City of Newton, Massachusetts
Department of Planning and Development
1000 Commonwealth Avenue Newton, Massachusetts 02459

MEMORANDUM

DATE: March 1, 2013
TO: Board of Aldermen
FROM: Candace Havens, Director of Planning and Development
Eve Tapper, Chief Planner for Current Planning 
SUBJECT: #258-12 BH NORMANDY RIVERSIDE, LLC/MASSACHUSETTS BAY TRANSPORTATION AUTHORITY petition for a change of zone to Mixed Use 3/Transit Oriented District for a portion of land located at 327 Grove Street, also identified as Section 42, Block 11, Lot 3A, currently zoned Public Use.

#258-12(2) BH NORMANDY RIVERSIDE, LLC/MASSACHUSETTS BAY TRANSPORTATION AUTHORITY petition for a SPECIAL PERMIT/SITE PLAN APPROVAL to construct a mixed use, transit-oriented development including an office building of approximately 225,000 sq. ft., a residential building containing 290 apartments with 5,000 sq. ft. of retail space, a three story building containing approximately 15,000 sq. ft. of retail space and approximately 8,000 sq. ft. of community space, and related site improvements; to permit office use on the ground floor, medical office use, retail and personal establishments of more than 5,000 sq. ft., eating an

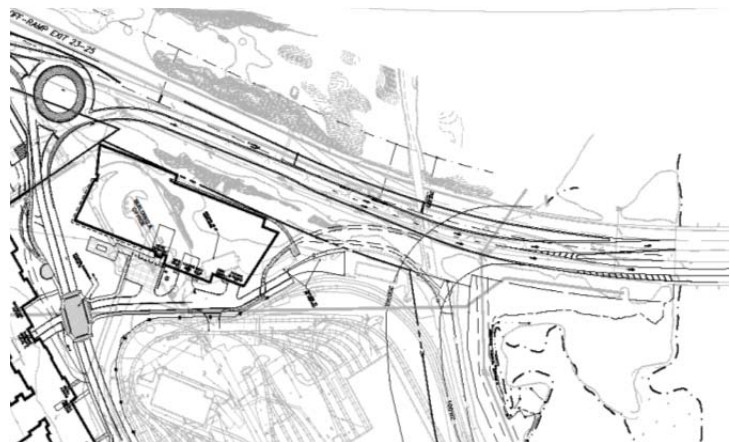
Vehicular Access from the west. At recent public hearings, many expressed strong preferences for enabling left turns in and out of the westerly side of the site as depicted in the B-2 Option in the Draft Environmental Impact Report (DEIR) (shown below), as this would reduce the amount of traffic on Grove Street by about 1500 vehicle trips per day over the “no left turn out” option. The City’s peer reviewers from Fay, Spofford, and Thorndike (FST) raised concerns about sight

lines from cars leaving the site heading south towards Grove Street, as drivers will be looking uphill and around a curve where northbound cars will likely be picking up speed as they approach the intersection; this condition will be worsened by vegetation or snow in this area. Since that time, City representatives met with other public officials, including the Secretary of Transportation, Lieutenant Governor, State

B-2 or not B-2? The most satisfactory solution appears to a roundabout (Attachment A). A well-designed roundabout at the westerly access allows for cars to enter and exit from all desired directions, slows cars as they come downhill from Grove Street, and makes it nearly impossible for a serious accident to occur. The Federal Highway Administration (FHWA) makes the final determination as to whether this will be accepted as a means of egress to the site. FHWA and MassDOT staffs have reviewed the design and concurred that this alternative is preferred, and are coordinating with VHB to prepare documents for a formal request for approval. MassDOT Administrator of the Highways Division, Frank DePaola will be available to answer further questions about the process and timeline at the Working Session.

ATTACHMENT A: REVISED SITE PLAN WITH ROUNDABOUT ON WESTERLY SIDE

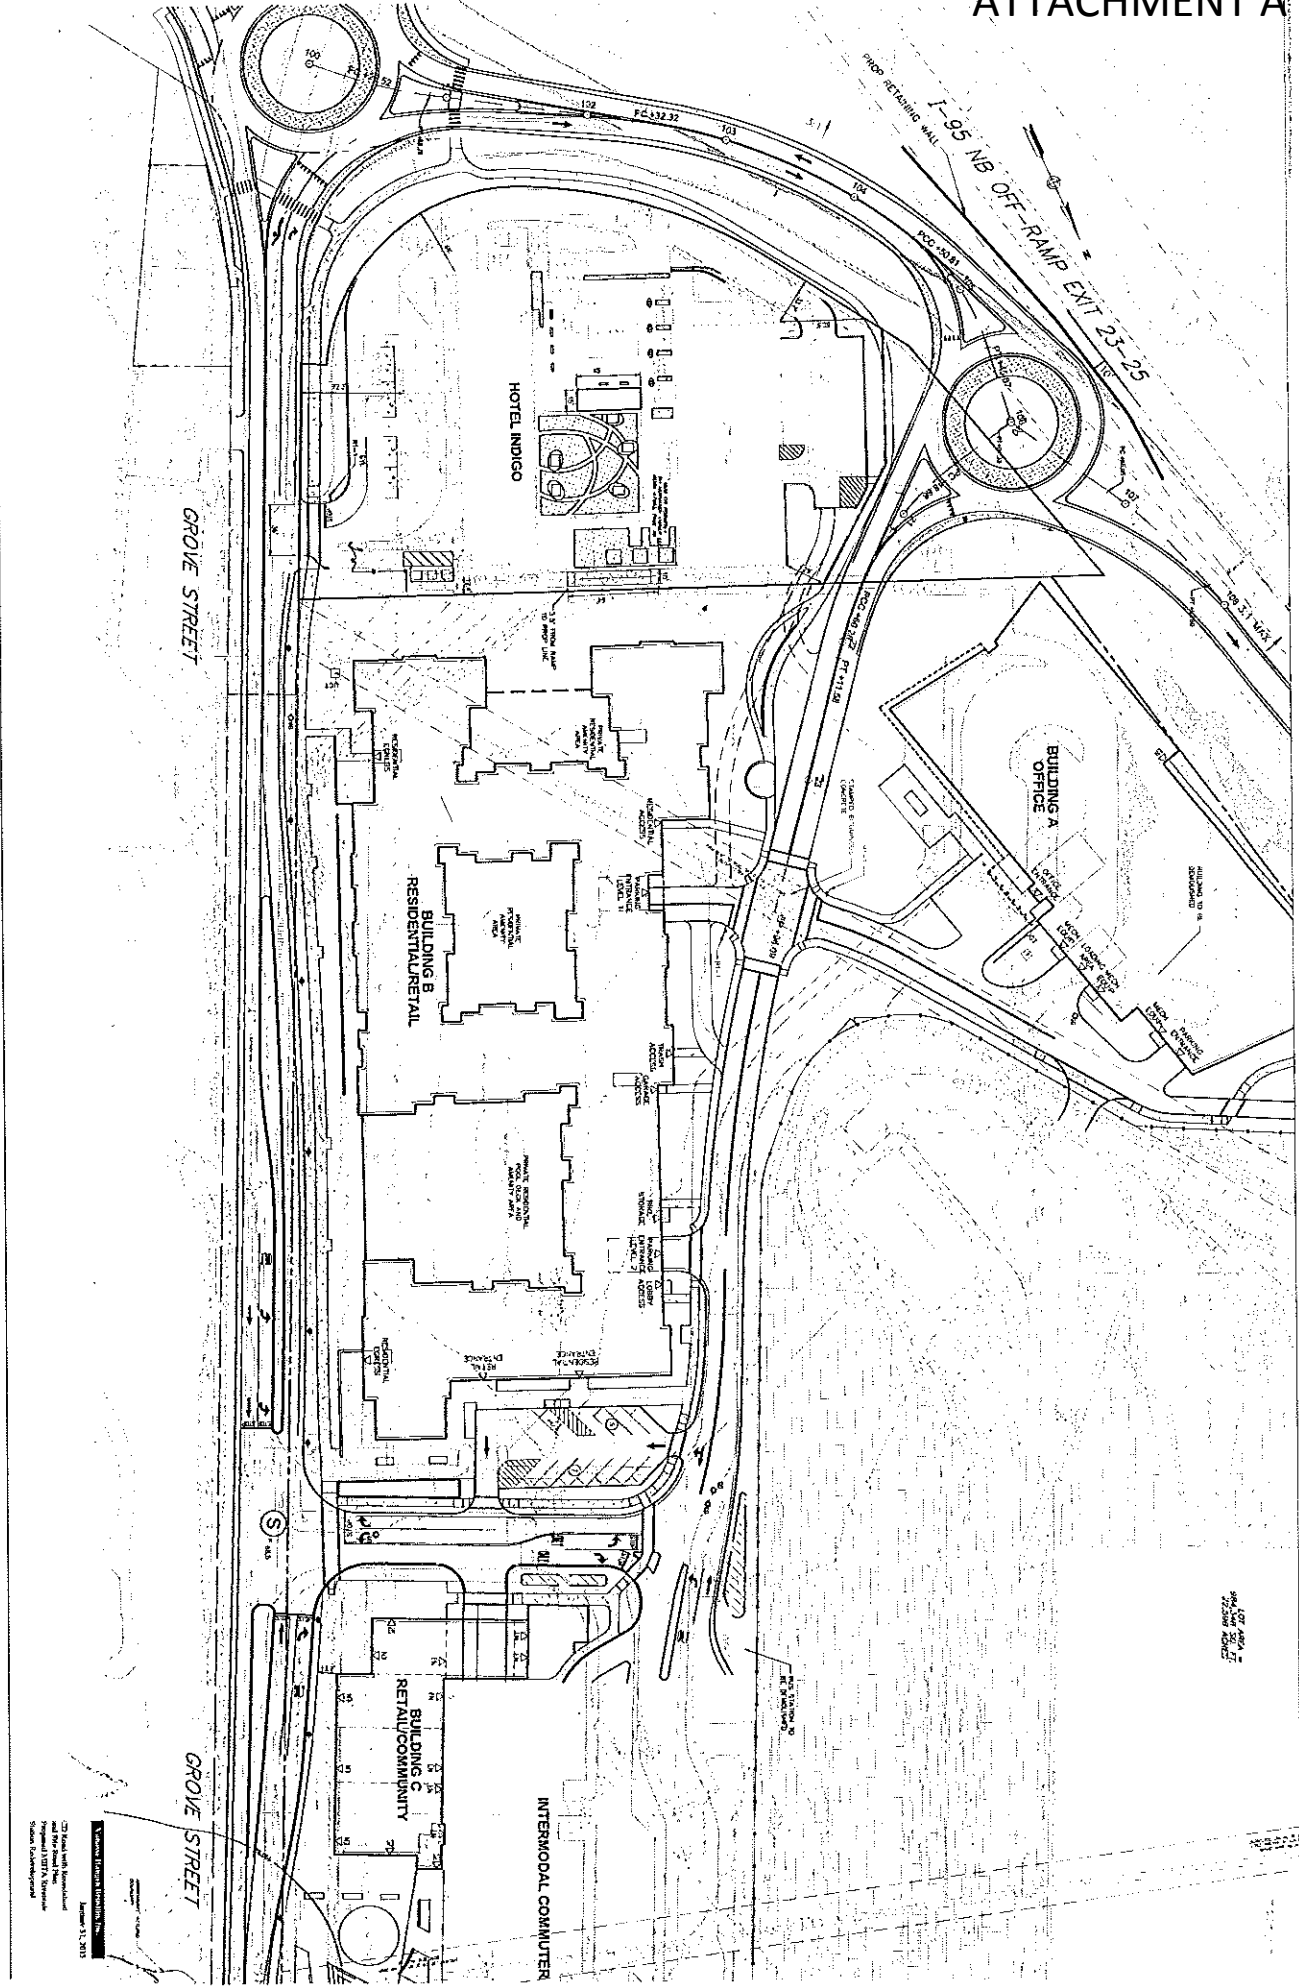
Another benefit of the redesign of this intersection is that access from the Hotel Indigo parking lot can be provided with a smoother transition to the Riverside site with less interruption to the landscaped area in front of the residential area. There appear to be two possible roadway extensions from the rear parking to the middle of the road coming off the westerly roundabout into the site, and another that goes from the parking lot to the driveway of the residential building. In staff's view, the first, shorter roadway is all that is needed to enable a connection that will make it easier for valets from Hotel Indigo (discussed later in this report) to provide quick service. The second, longer roadway interrupts an area that was proposed for landscaping and outdoor space for the residential buildings and could remain as such. It should be noted that there no longer is an interior roundabout proposed, which was an attractive feature at the entrance; however it is clear that the alternative two-way stop intersection that replaces it will allow free flow of traffic in the site and will take up less area and will provide additional opportunities for landscaping and open space.
